THE UNIVERSITY OF NORTH CAROLINA
AT
CHAPEL HILL

Re: Development Plan Modification No. 2 – Supplement #1

**Development Plan Modification #2
Supplement #1
May 3, 2004**

Modification #2 - Map 1 Supplement

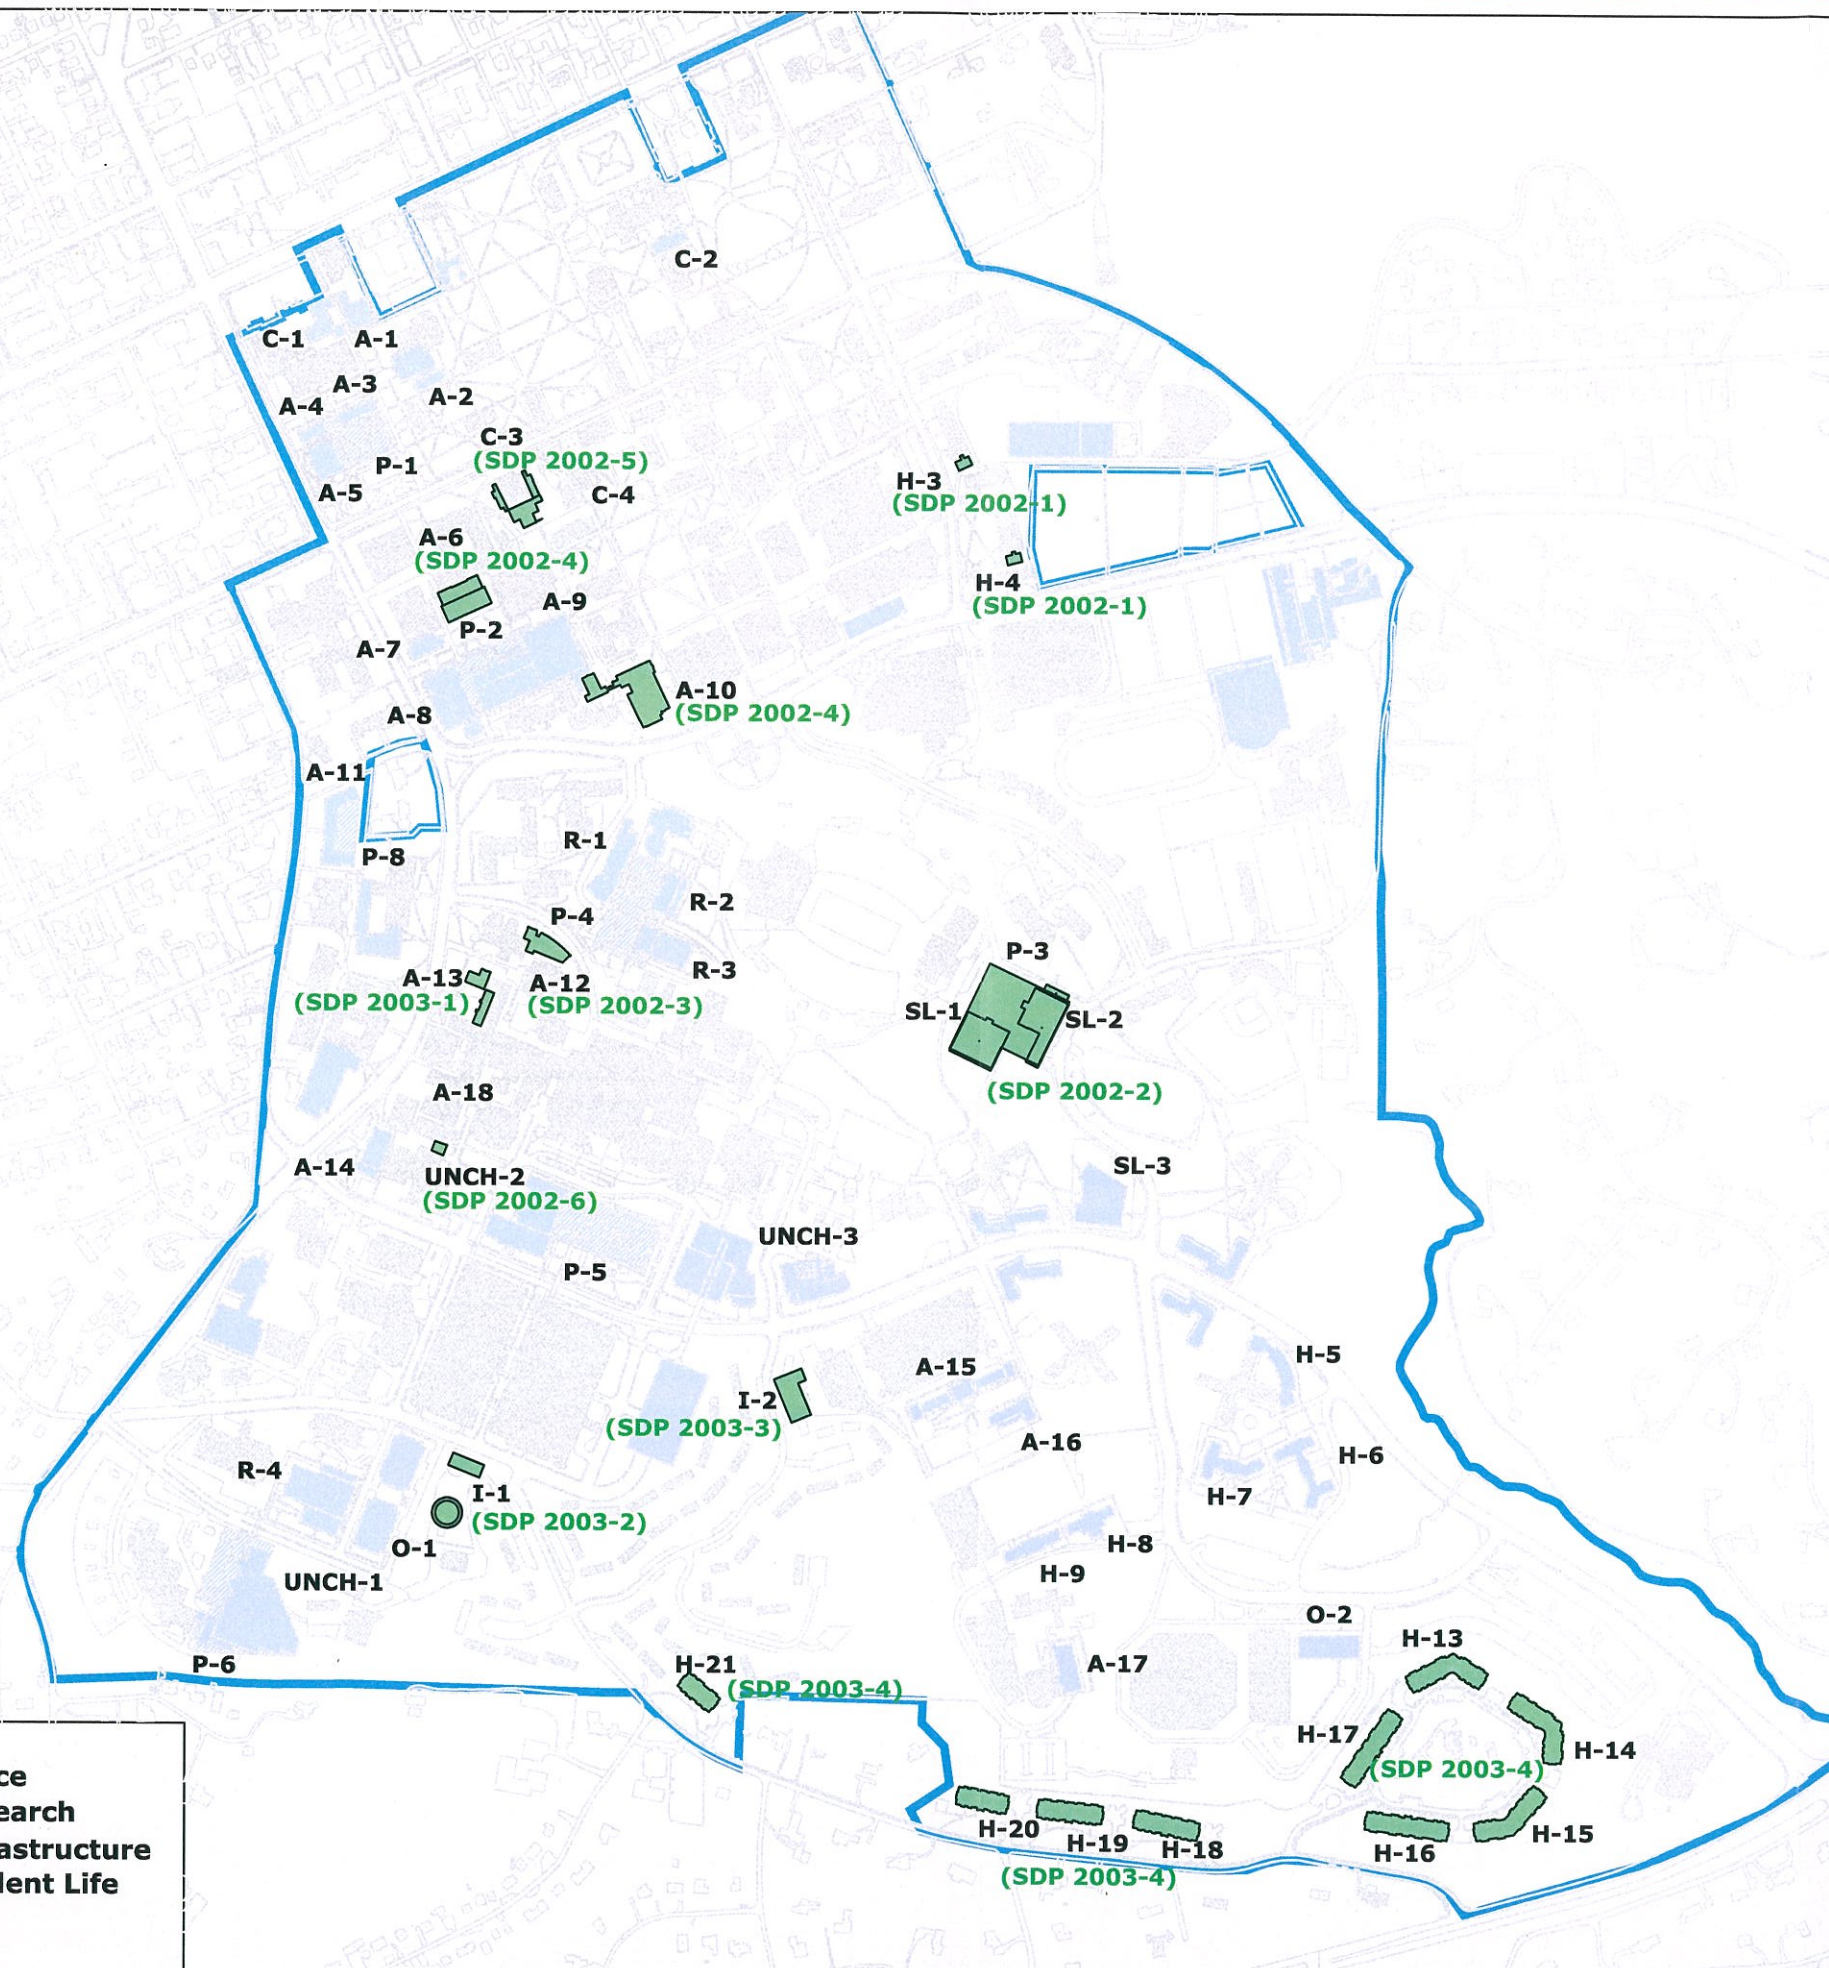
- e. Please Revise Modification #2- Map 1.
- i. Remove deleted building #'s H-1, H-2, P-7

See attached revised Modification #2-Map 1.

Modification #2 - Map 2 Supplement

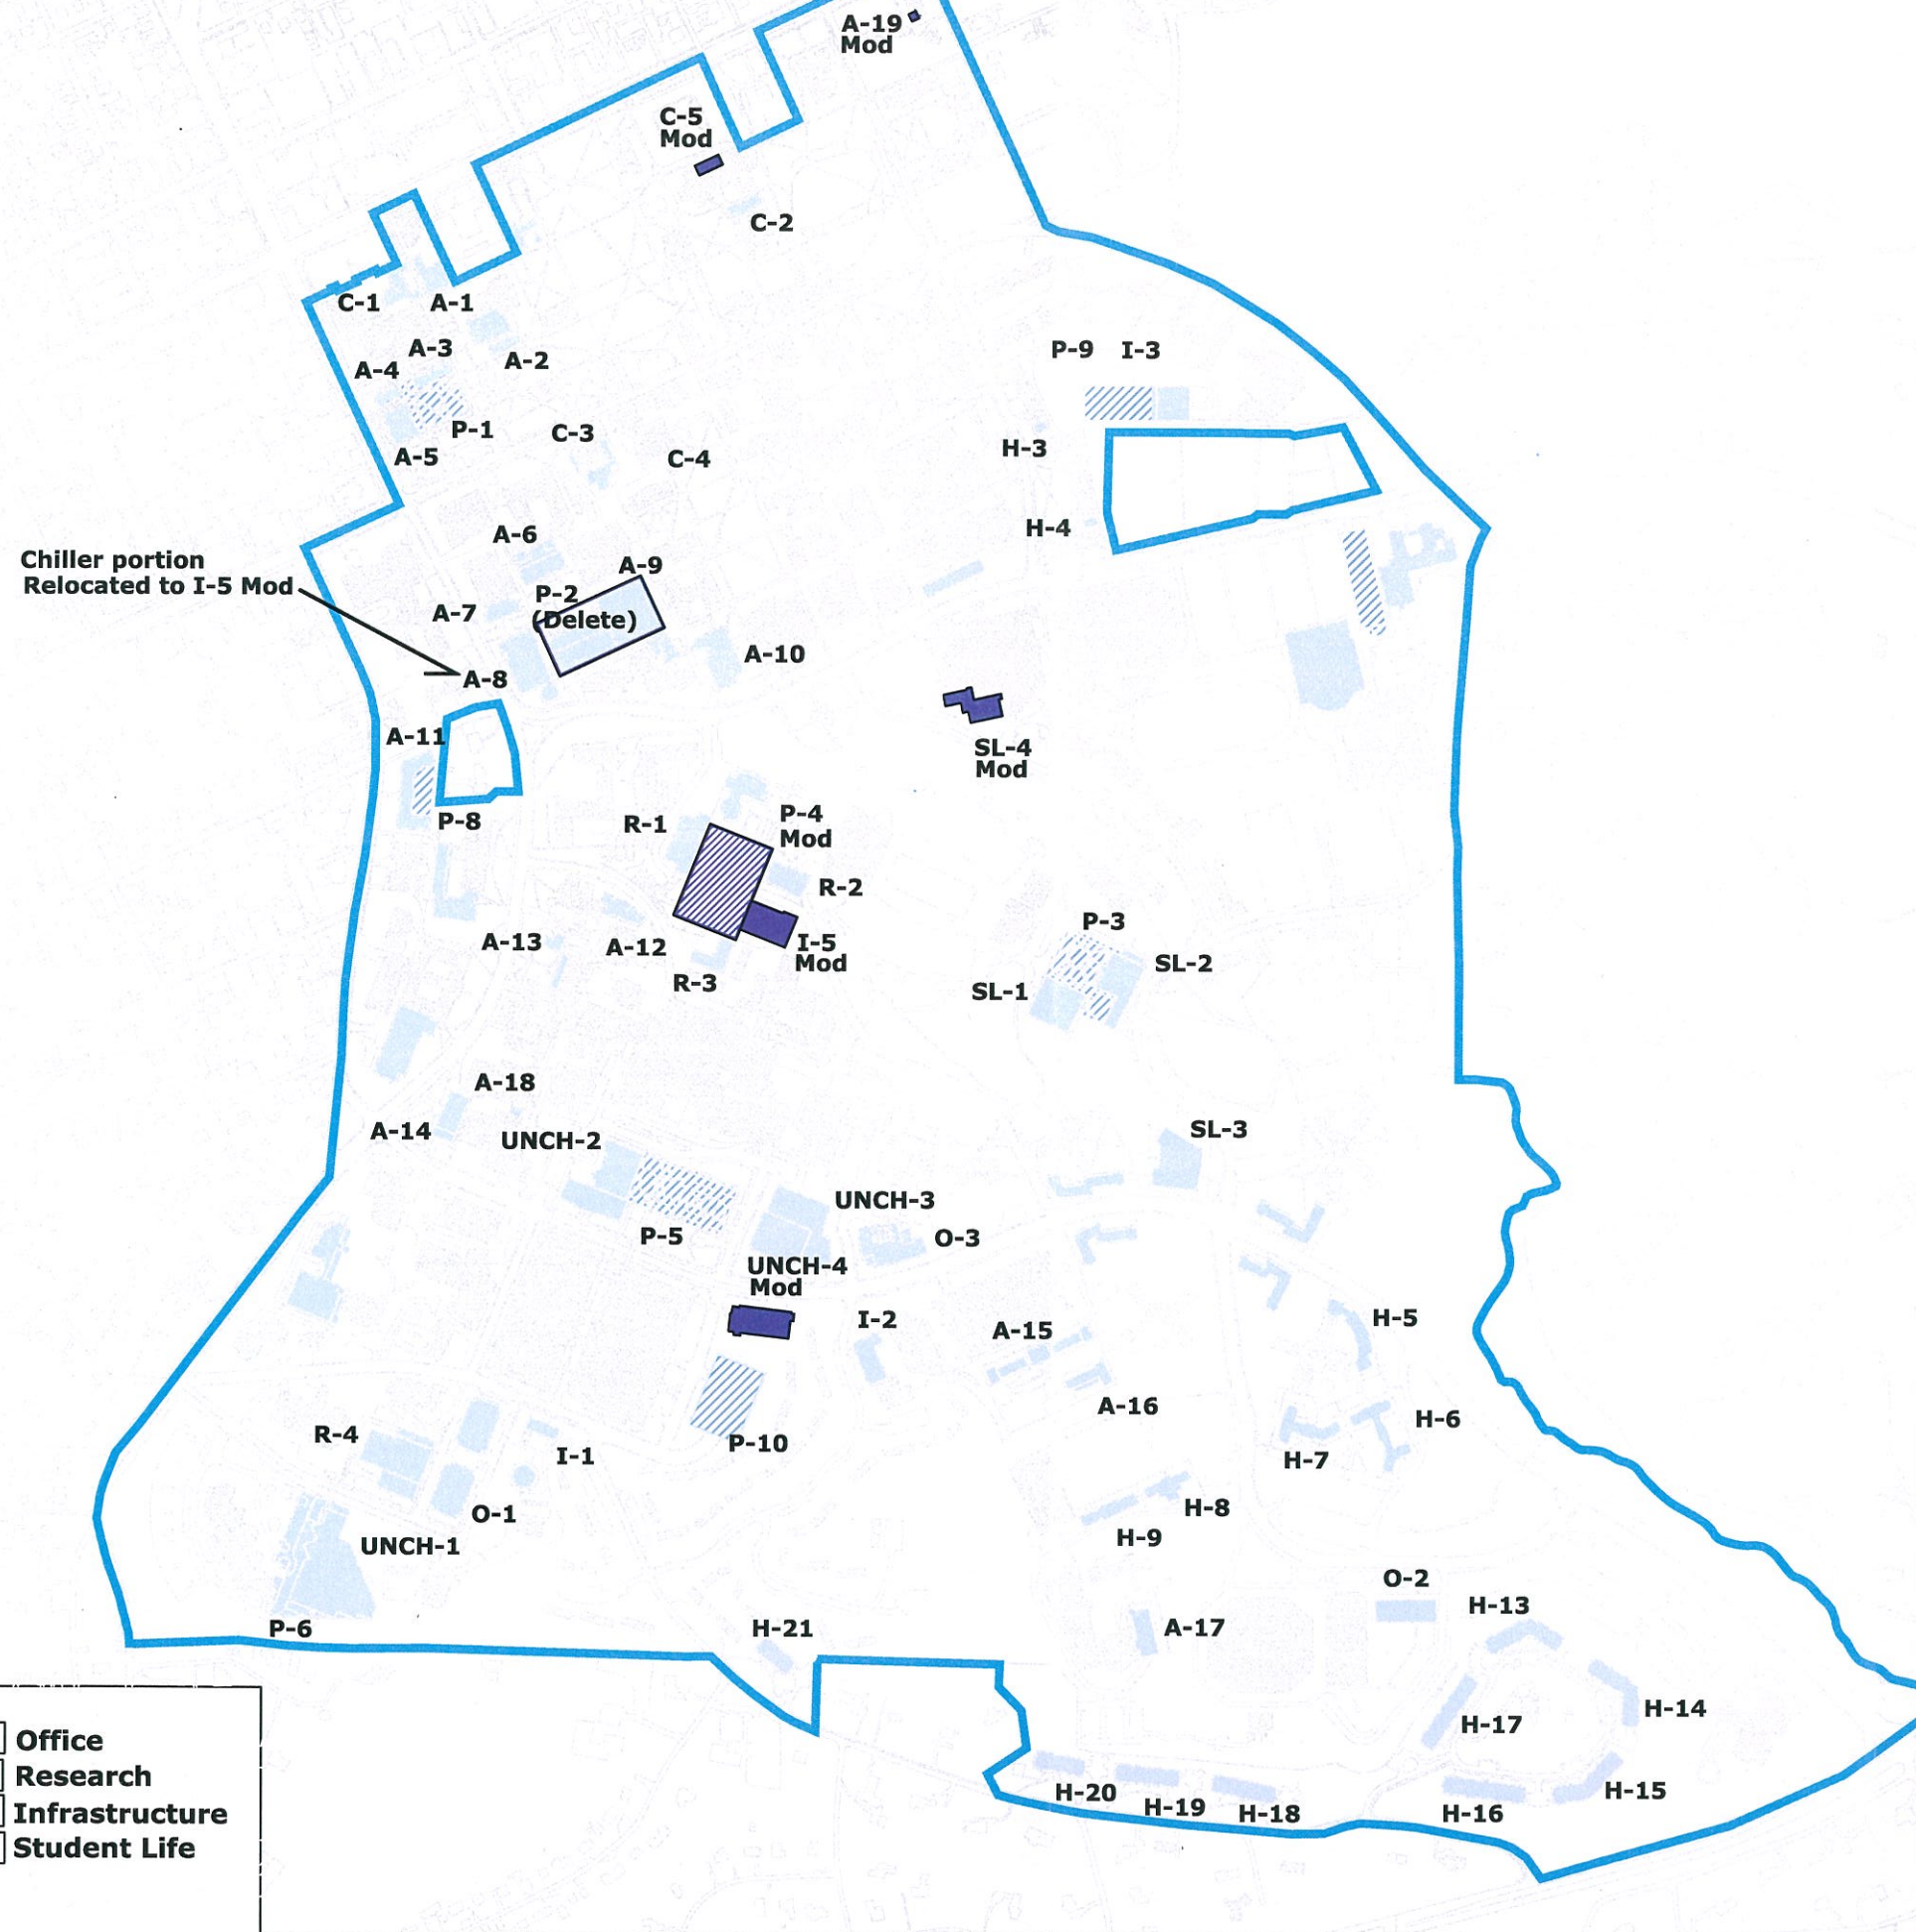
- f. Please Revise Modification #2- Map 2.
- i. Included a "construction timetable."
 - ii. Remove deleted building #'s H-1, H-2
 - iii. Note relocation of chiller from building A-8

See attached revised Modification #2-Map 2.

Figure 4 - 12
 Traffic Calming and Pedestrian Safety Measures
 Modified May 3, 2004

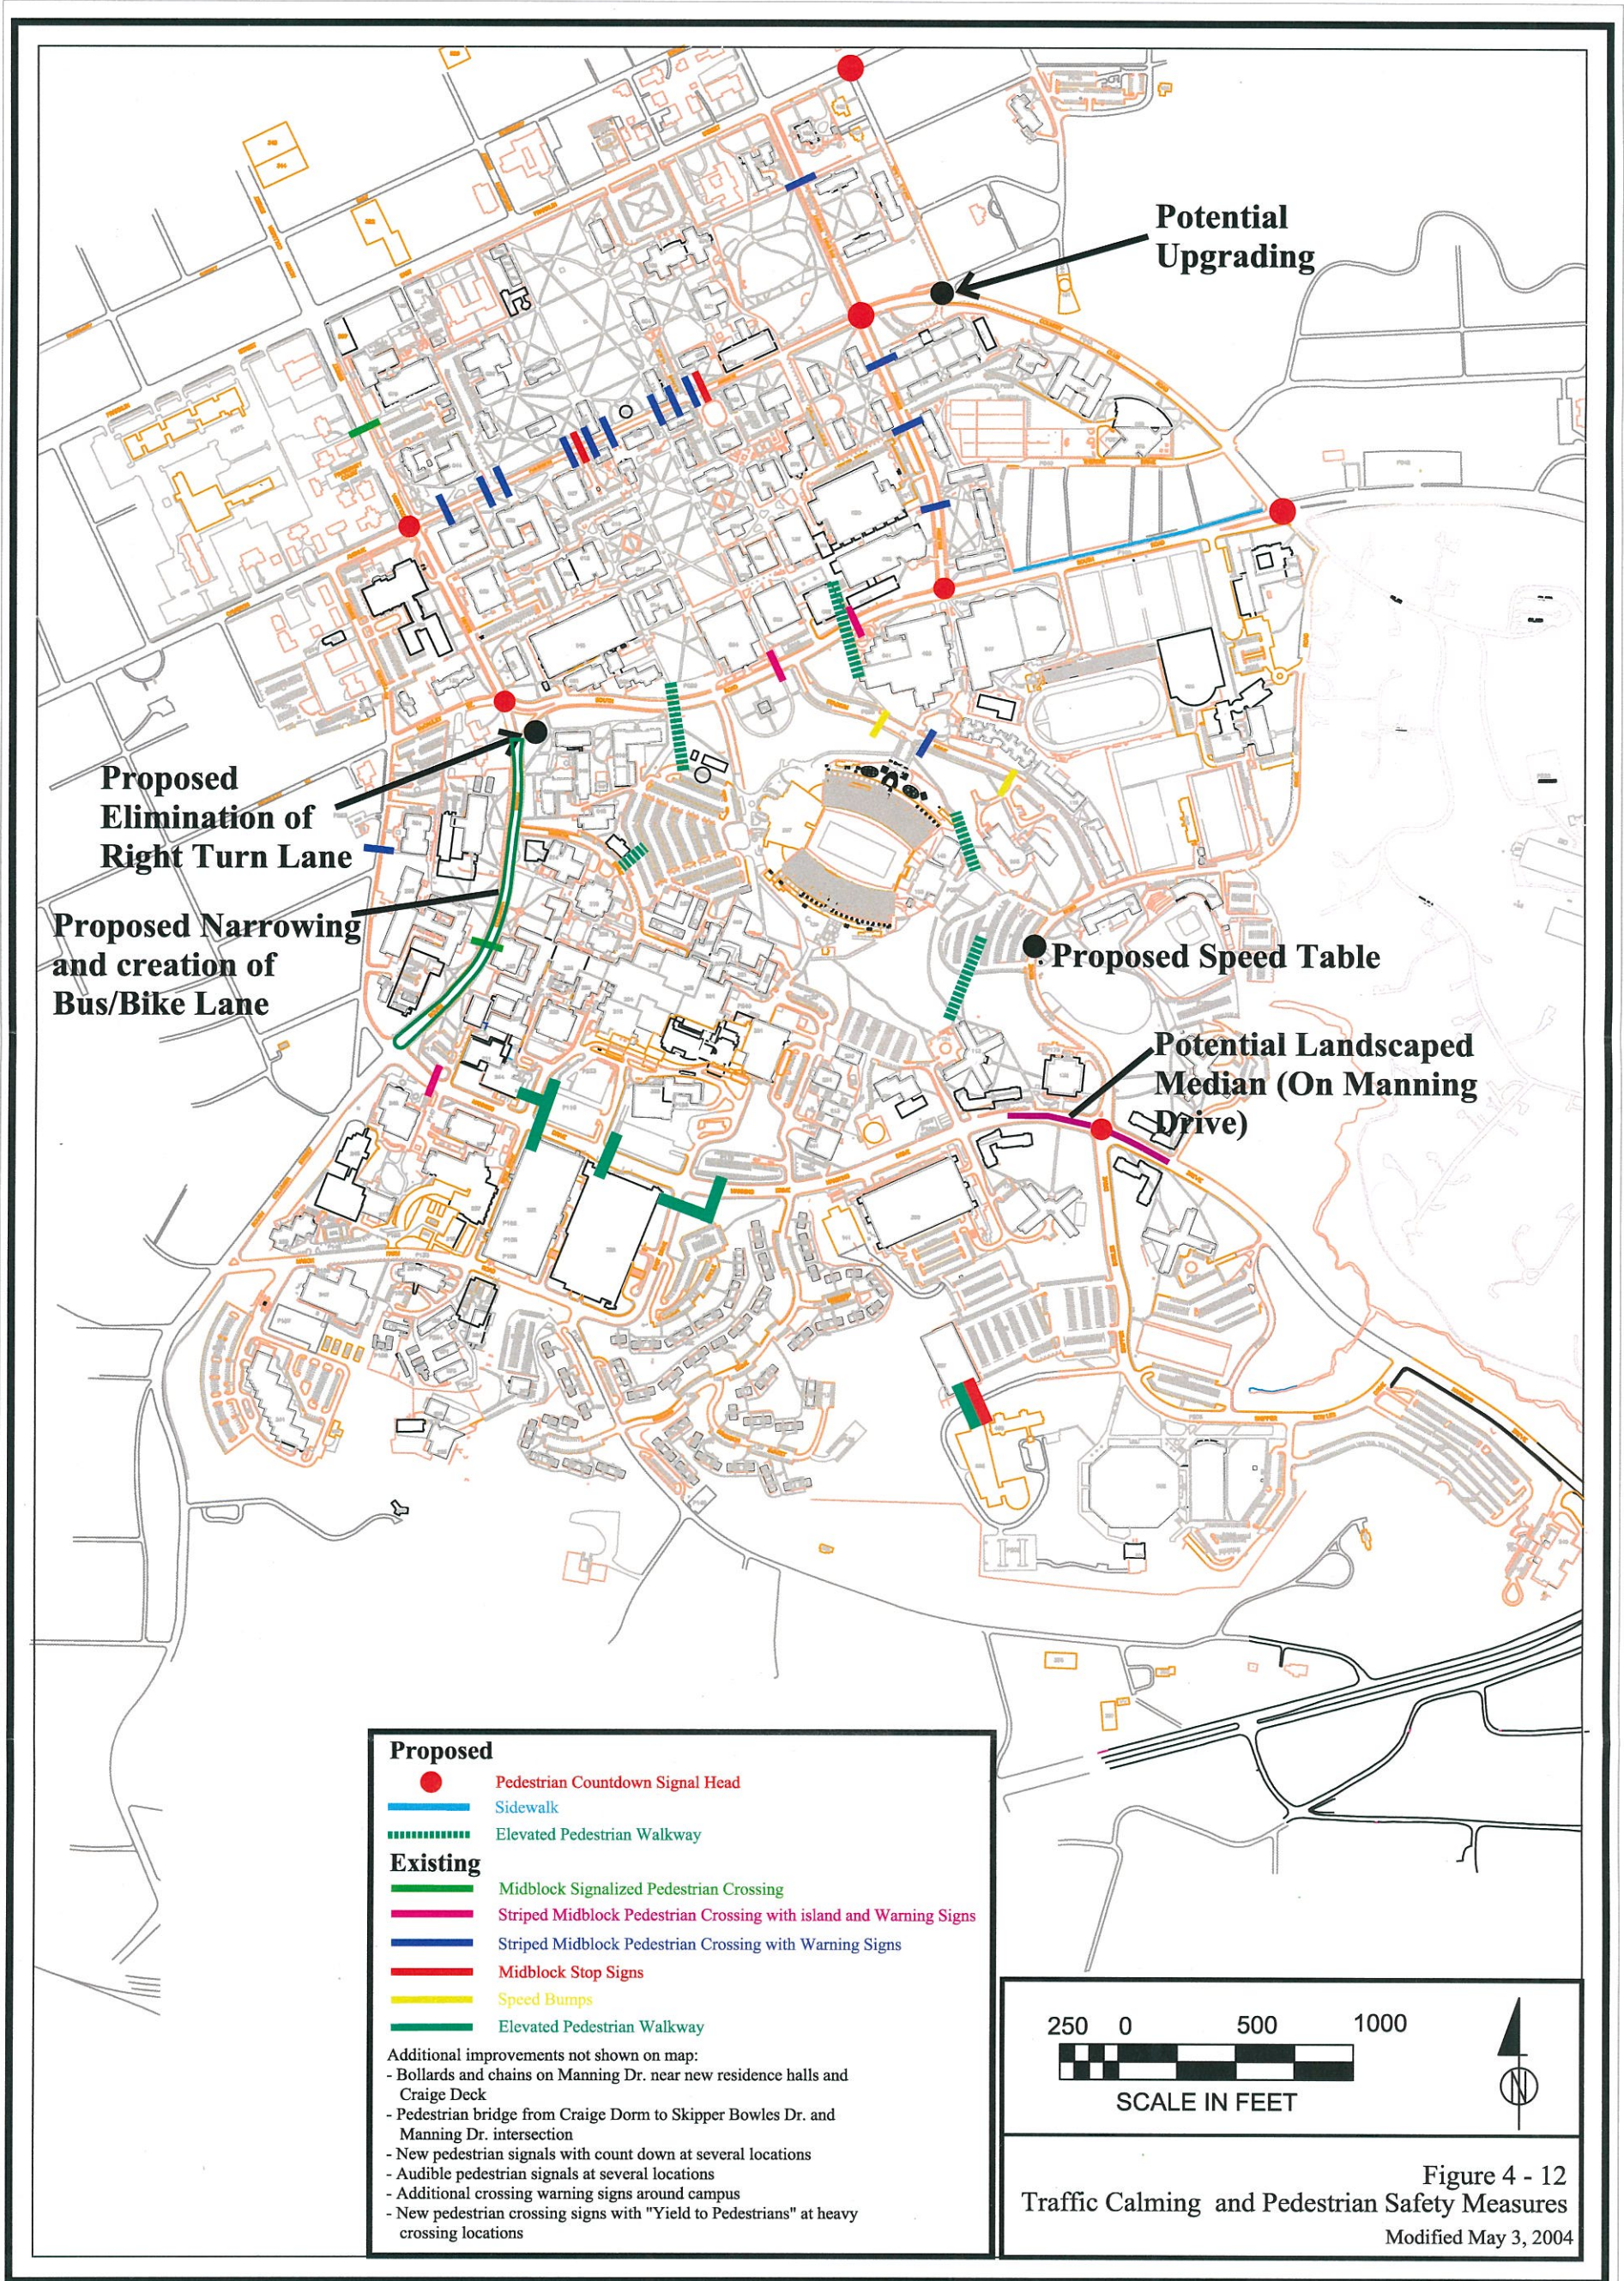
- b. Please clearly identify all elevated pedestrian walkways on Figure 4-12

- d. Figure 4-12 needs to be accompanied by an implementation schedule for roadway improvements in order to fully understand the proposed improvements.

Please see attached revised Figure 4-12.

Figure 4-12 is attached. The figure has been revised to include elevated pedestrian walkways.
